RE: St. Lucie Unit 2
Docket No. 50-389
Proposed License Amendment
Second Request for Additional Information Response
WCAP-9272 Reload Methodology and
Implementing 30% Steam Generator Tube Plugging Limit

Second Request for Additional Information Response

WCAP-9272 Reload Methodology and

Implementing 30% Steam Generator Tube Plugging Limit

Sequence of Events for the Post-Trip Steamline Break with Loss of Offsite Power

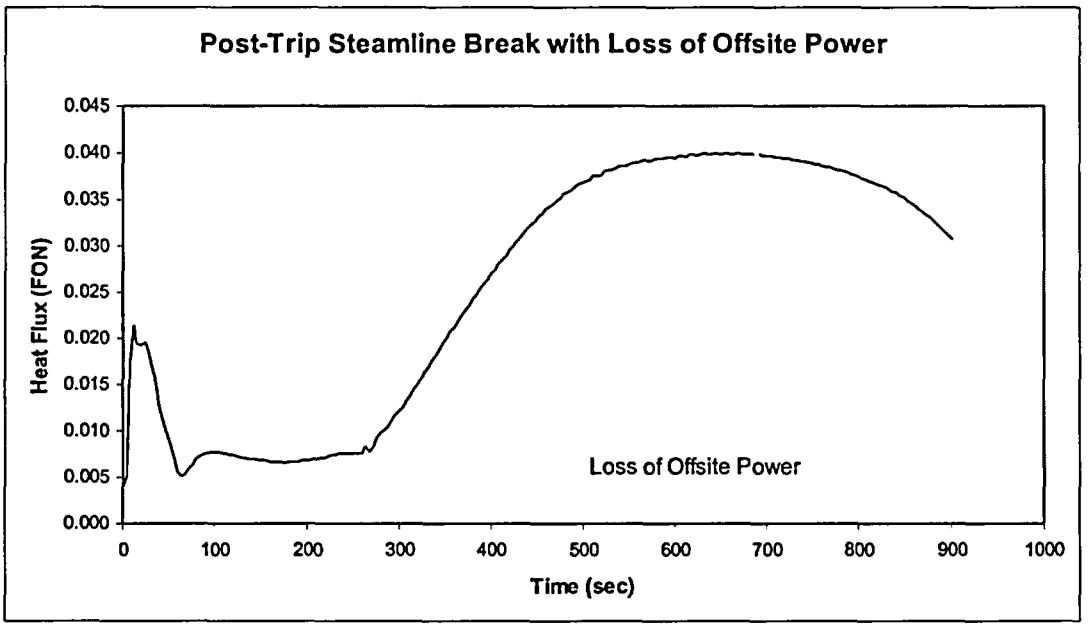
NRC Request 5.b: FPL requests a change from the current licensing basis for the timing of LOAC. The response to previous RAI question 8.e states that the accident analyses consider the possibility of the LOAC occurring "simultaneously with the pipe break," "during the accident," and "offsite power may not be lost." In the submittal and in response to RAIs, FPL provides justification that the Post-Trip MSLB without LOAC case is more limiting than Post-Trip MSLB with a coincident LOAC. However, the submittal provides no justification for

As noted in the response to 5a., the steamline break from hot full power conditions analyzed to a post-trip condition did not result in a return to criticality. Therefore, the timing of the loss of offsite power beyond 3 seconds has no bearing on the results for the post-trip steamline break event. For the HZP steamline break case, which is the limiting case for a post-trip condition, the turbine is not on-line as insufficient power is generated to drive the turbine. Therefore, a reactor trip from a HZP condition is not expected to cause a disturbance on the grid which could cause a loss of offsite power to the reactor coolant pumps. However, sensitivities were run assuming that a loss of offsite power occurred at 0 seconds, 3 seconds, and 12 seconds following reactor trip. In each of these cases, the safety injection signal on a low pressurizer pressure signal occurred following the loss of power signal and within a window of 4 seconds. This is shown by the results presented in the table shown below. For the post-trip steamline break event with LOAC, the limiting point in the transient occurs around 650 seconds. It is around 650 seconds where the peak heat flux occurs, as shown in the figure, which is the limiting condition with respect to the DNB design basis. The effect of a difference in the timing of the loss of offsite power and the initiation of safety injection has essentially a negligible effect on the limiting point in the transient which, as described in Appendix A of the licensing report, is non-limiting compared to the post-trip steamline break case with offsite power available.
